Access Compliance Report

Public Rights-of-Way

Intersection ID: 29125	Main Street: ALDERPOINT_LN	Cross Street: APPLIEDALE_DR	Location: S
ADA ID: 736F1E3DDC35	Ramp Type: BlendTrans1	Initial Pass/Fail: Fail	Overall Compliance: No
Severity Score: 8.75			
Codes/Mitigation Info/Possible Solution		Field Measurements/Component Compliance

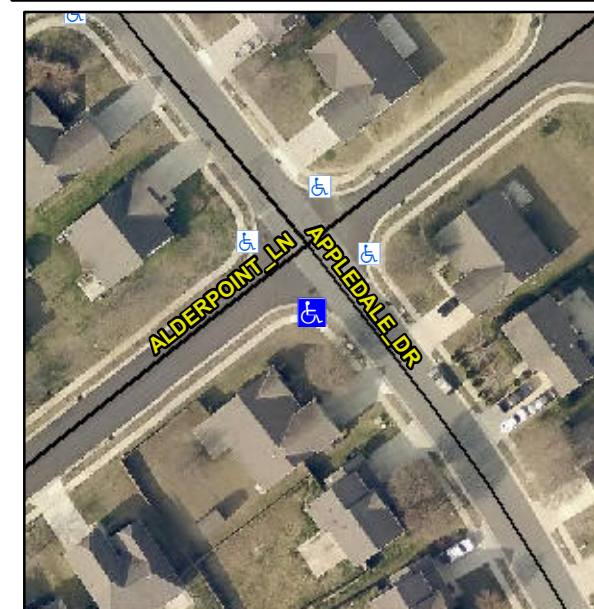
Not Found, R304.5.1

Compliance	Description	Data	Compliance	Description	Data
N/A	Ramp Length (in)	46.0	Yes	BlendTrans Slope (%)	1.3
No	Ramp Width (in)	46.0	Yes	BlendTrans XSlope (%)	0.2
N/A	Flare Type LT	N/A	N/A	Flare Type RT	N/A
N/A	Flare Slope LT (%)	N/A	N/A	Flare Slope RT (%)	N/A
N/A	Flare Traversable LT?	N/A	N/A	Flare Traversable RT?	N/A
N/A	Landing Length (in)	N/A	N/A	DWS Provided?	N/A
N/A	Landing Width (in)	N/A	N/A	DWS Contrast?	N/A
N/A	Landing Slope (%)	N/A	N/A	DWS Length (in)	N/A
N/A	Landing X Slope (%)	N/A	N/A	DWS Full Width?	N/A
N/A	Landing Curb? (Y/N)	N/A	N/A	DWS Offset (in)	N/A
N/A	Shared Landing?	N/A			
N/A	Gutter Ponding?	N/A	N/A	Gutter Slope (%)	N/A
N/A	Gutter Lip Ht (in)	N/A	N/A	Gutter X Slope (%)	N/A
N/A	Painted X Walk1?	No	N/A	Painted X Walk2?	No
	X Walk 1 Direction	To NE		X Walk 2 Direction	To NW
	X Walk 1 Width (in)	N/A		X Walk 2 Width (in)	N/A
	X Walk 1 Slope (%)	4.0		X Walk 2 Slope (%)	2.4
	X Walk 1 X Slope (%)	1.0		X Walk 2 X Slope (%)	3.0

N/A	Ramp inside XWalk1?	N/A	N/A	Ramp inside XWalk2?	N/A
	Road Slope (%)	0.1		Clear Space?	N/A
	Road X Slope (%)	3.4	N/A	Clear Space to XWalk (in)	N/A
N/A	Any Obstructions?	N/A	N/A	Storm Grate/Utility Hazard?	N/A
	Obstruction Type			Storm Grate/Utility Type	
		N/A			N/A
			Yes	Surface Condition? (G/P)	Good
			No	Curb Slope (%)	10.4

Remove & Replace Curb Ramp With Two New Directional Ramps or Equivalent.
